North Saskatchewan ARP

9213 97 St NW is fully within the *North Saskatchewan River Valley and Ravine System Protection ARP*.

Several portions of this development application conflicts with the ARP:

Figure 6: 1.11 km detour to 87 Ave access

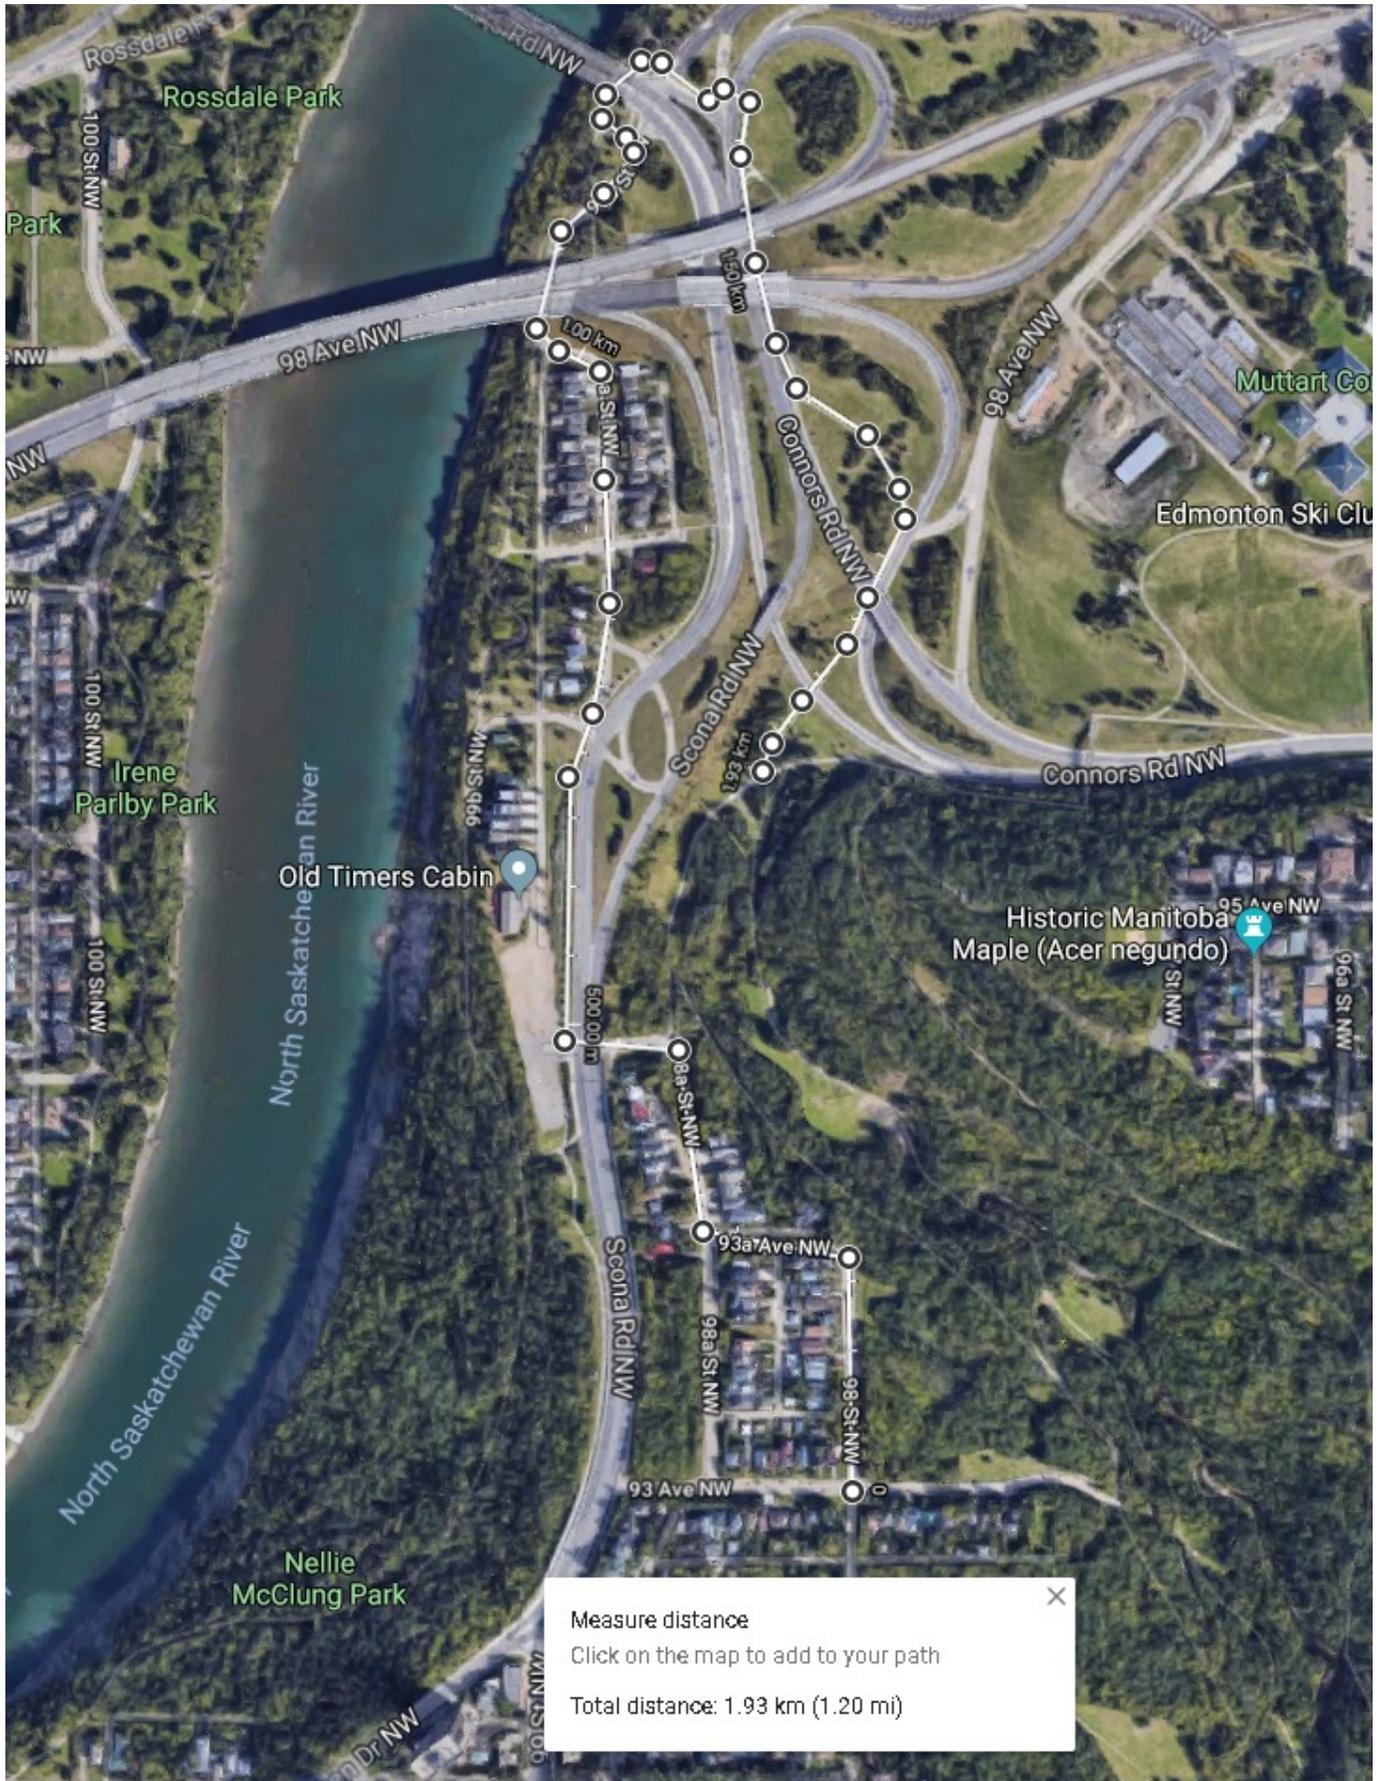
The nearest alternate paved access to Mill Creek Ravine then is 87 Ave, which is 1.11km away from the intersection of 98 St and 93 Ave (walking distance: over a 13 minute walk for a fit person). Accessing Mill Creek Ravine via Connors Road, meanwhile, is a 1.93km walk that crosses under the Low Level Bridge (there are no pedestrian crossings of Scona Road north of 98a St). Both options involve significant elevation changes as well, presenting an additional barrier.

In addition to removing a key access point for handicapped persons, the 93 Ave access is far enough away from the other access points that its removal would be a significant impediment to access for all users, especially people with strollers, bicycles, child trailers, walkers, and other mobility constraints. (3.2.18)

Figure 8: View of scale, looking south at house and east path

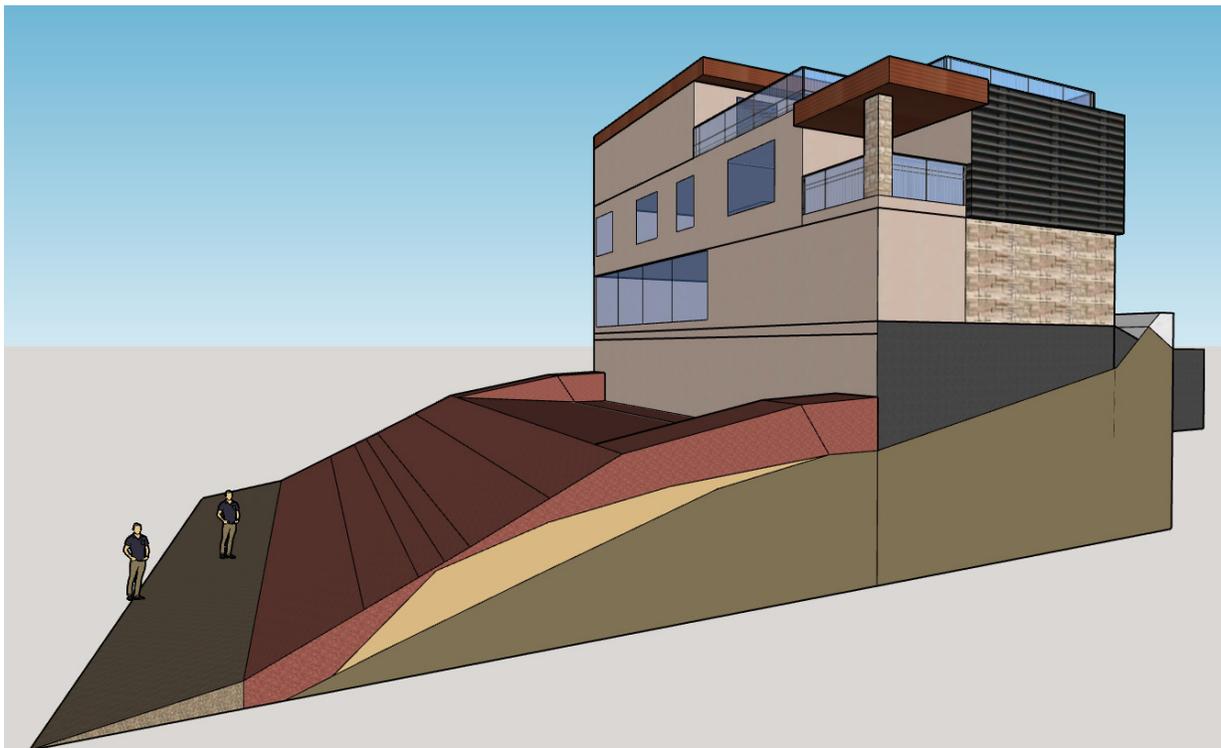
This development is 17.5m along the west face, over twice as long, and 11.3m along the south face, while being over 50% taller at 10m. Additionally, its east walkout basement adds significant size compared to the previous home, with the imposing massing of a 4-story flat-roofed structure.

With a footprint of approximately 2150 sqft (not including south deck), the footprint alone is over 2.5 times larger than the the previous building's roughly 815 sqft. Combined with the added height and flat roof, and conjoined structure with the attached garage, this proposed house is massive compared to the previous one, and its west face will significantly disrupt the forested ravine shared use trail, which otherwise enjoys an undisrupted view free of other developments north of the Mill Creek pool parking lot. Additionally, as there is no vegetation on or above the retaining wall on the east side of the property, users of the east walking path will have an unimpeded view of nearly the entire house. Correspondingly, residents in the house will have an
